R301 Ultra

Serial Numbers 91/xxxx

1- Speed, 120 Volt, 1 Phase, 60Hz., 1/2 HP.
1725 RPM, 7.2 Amps

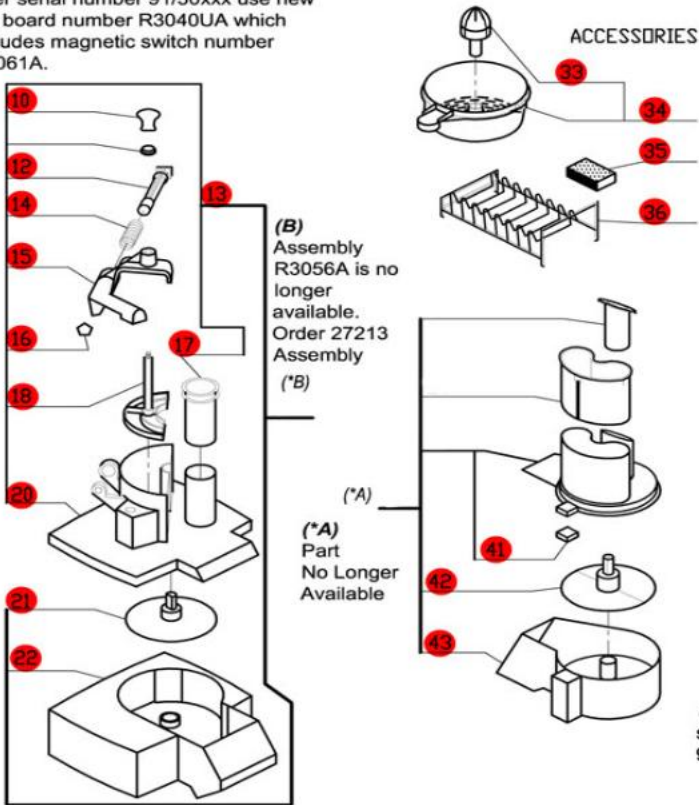
(*F)
After serial number
91/41450
New bowl rod metal
bushings R3071UA
replaces rod with plastic
caps.

(*E)
Part Number R3040U comes complete
with magnetic switch.
After serial number 91/30xxx use new
PC board number R3040UA which
includes magnetic switch number
R3061A.

(*B)
Assembly
R3056A is no
longer
available.
Order 27213
Assembly
(*B)

(*A)
Part
No Longer
Available

CONVERSION KIT: R3006K
1-R3006UB-Magnetek Motor
1-R3004B
3-R3025A
2-R1716
1-R222

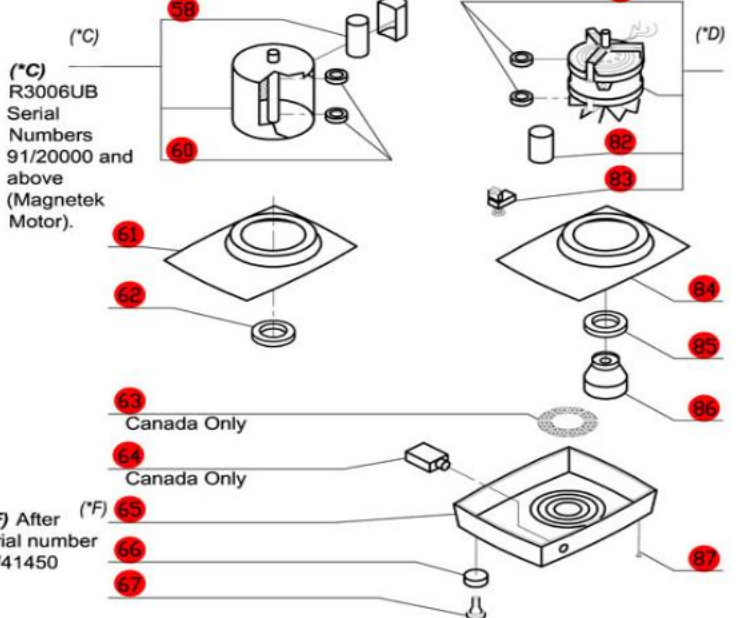
(*D) Use conversion kit R3006K
to replace open frame motor of
R301U.
Serial Numbers 91/00001 to
number 91/20000:

(*C)
R3006UB
Serial
Numbers
91/20000 and
above
(Magnetek
Motor).

(*F) After
serial number
91/41450
